Docket No. LC 77

PACIFICORP, dba PACIFIC POWER,

2021 Integrated Resource Plan.

Staff Opening Comments

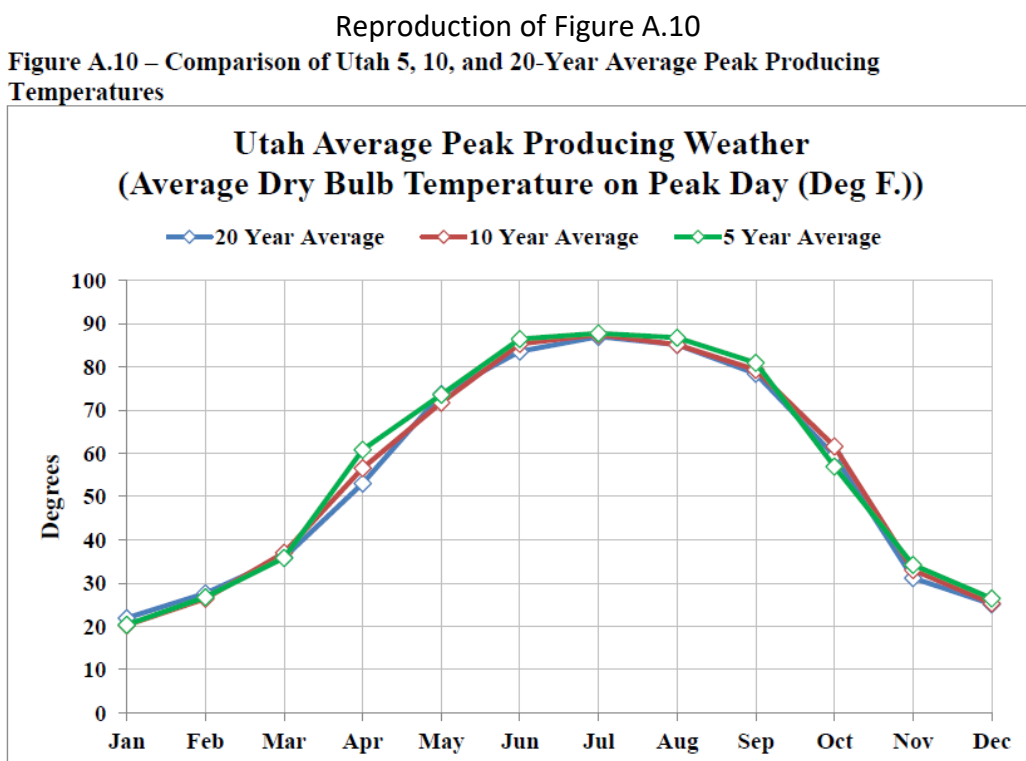
Figure A.10 shows that 5-year average temperatures are slightly higher than 10-year averages, which tend to be slightly higher than 20-year averages. This is indicative of a warming trend. Staff appreciates PacifiCorp consideration of this matter, and accepts that moving to a 5- or 10-year average for the base case load forecast does not seem likely to have a significant impact in this IRP. However, Staff would appreciate continued consideration of whether 5- or 10-year averages will be necessary to inform an accurate load forecast in future IRPs.

Figure A.11 – Load Forecast Scenarios for 1-in-20 Weather, Climate Change, High, Base Case and Low, pre-DSM

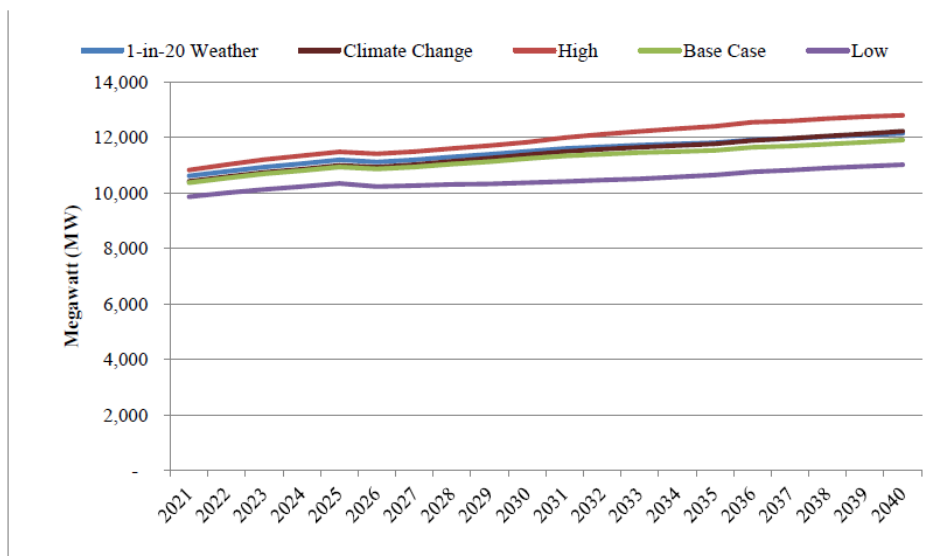
Staff appreciates the climate change scenarios considered in the 2021 IRP and finds the analysis to be somewhat useful for considering how many additional MW of capacity may be needed to reliably serve load under a variety of future climate scenarios. However, the 2021 IRP does not show what resource portfolio would be needed to meet the climate change load forecast using reference planning assumptions. The climate change scenario in the 2021 IRP utilizes the Social Cost of Carbon instead of MM reference case assumptions, and as such it cannot isolate the effects of the climate change load forecast. In future IRPs, it may be informative to include a climate change scenario that uses reference case (MM) IRP assumptions to demonstrate the resource decisions the Company would make if it incorporated climate change forecasts into its reference case planning.

Figure 6.4 from the 2021 IRP is shown here for reference:

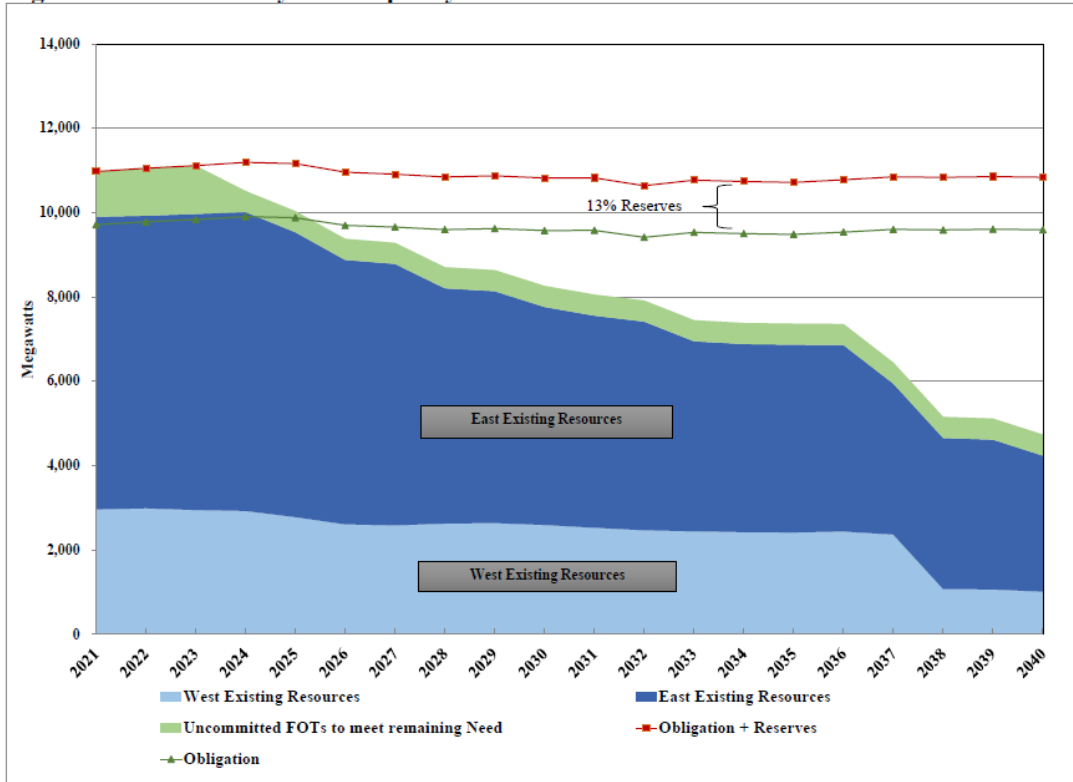
Staff highlights that available front office transactions are forecasted to decrease sharply in 2024, the same year as PAC’s first capacity need.

Figure 6.2 – Contract Capacity in the 2021 IRP Summer Load and Resource Balance

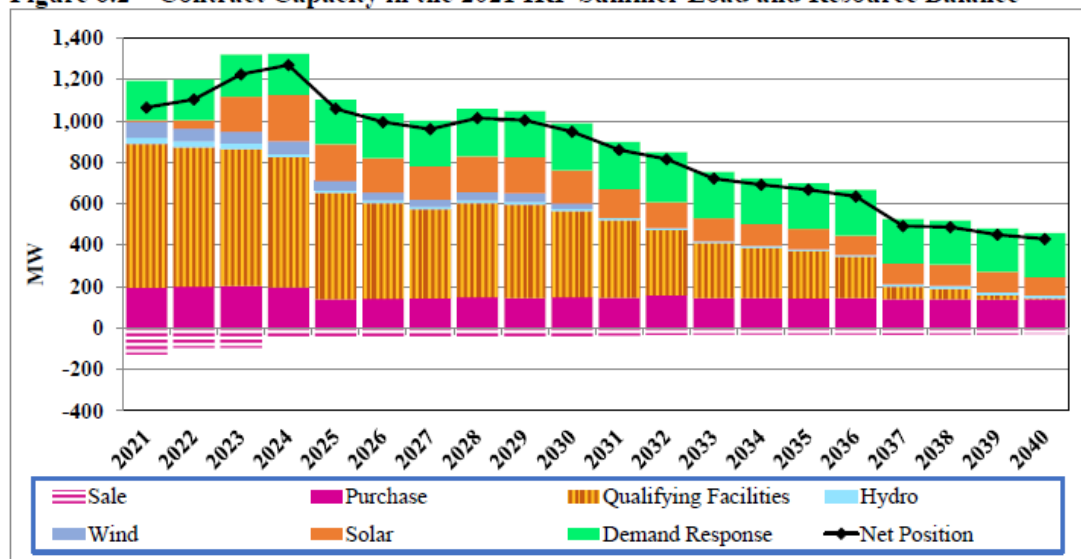
This topic has also been discussed in the Idaho Power 2019 IRP (LC 74), and the Commission directed Idaho Power to include a reasonable forecast of QF renewals in a sensitivity in its next IRP, and to report on how use of that QF renewal assumption would impact the preferred portfolio. The Order said that “some reasonable assumptions must be made” even though there is considerable uncertainty.⁶⁵

Staff recommends that PacifiCorp also begin to include a non-zero rate of QF renewals in its long-term forecast, or as a sensitivity. To address near-term reliability concerns, a zero-renewal rate could be used in the near-term Action Plan timeframe, while a reasonable renewal rate could be assumed thereafter.

Reproduction of 2021 IRP Figure 9.37:

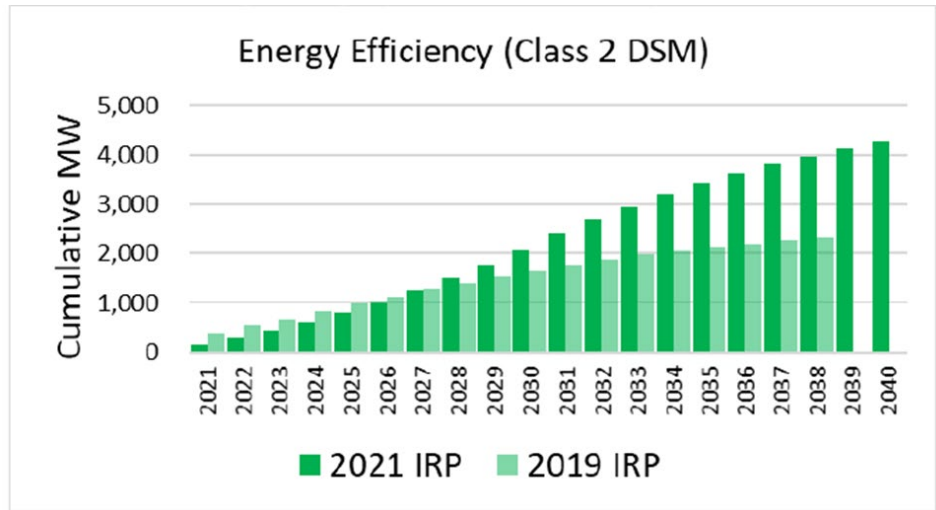
The Company's preferred portfolio includes 4,290 MW of energy efficiency over the planning period, which is significantly more energy efficiency than the previous IRP, particularly in the later years.

Figure 1.1 First Year Energy Efficiency Resource Selection for Preferred Portfolio

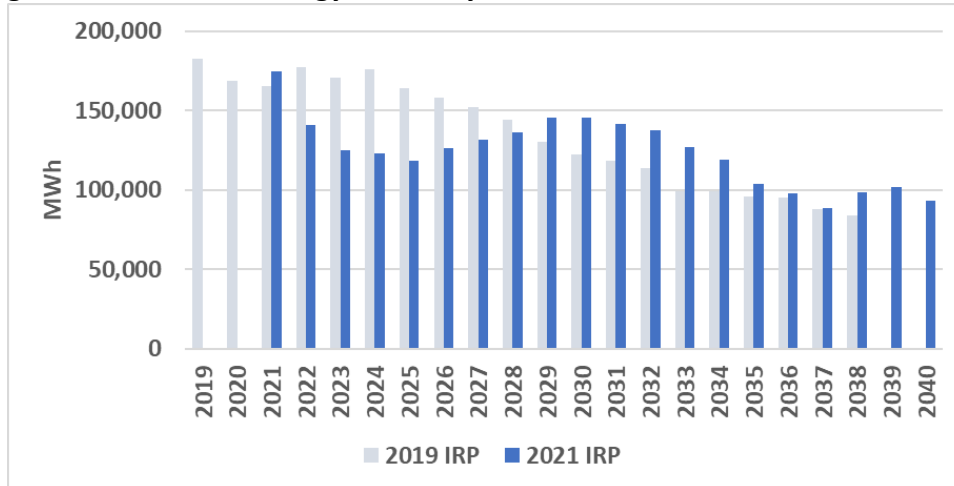
Staff compared the energy efficiency selection between IRPs for Oregon specifically, looking at the energy from the first year selected. Staff found that while the system selection of energy efficiency is higher, the selections for Oregon are lower in the current IRP, particularly in the earlier years.

efficiency. Energy Trust expects cost-effective energy efficiency acquisitions to increase in 2022 and 2023.⁷² This suggests that the model is not selecting all cost-effective energy efficiency and these selections should be modified to reflect near-term program activities in Oregon.

In Reply Comments, Staff requests that the Company provide an explanation of how these results will inform energy efficiency acquisition in Oregon. Staff is particularly interested in any modifications the Company intends to make to be consistent with available cost-effective energy efficiency in Oregon.
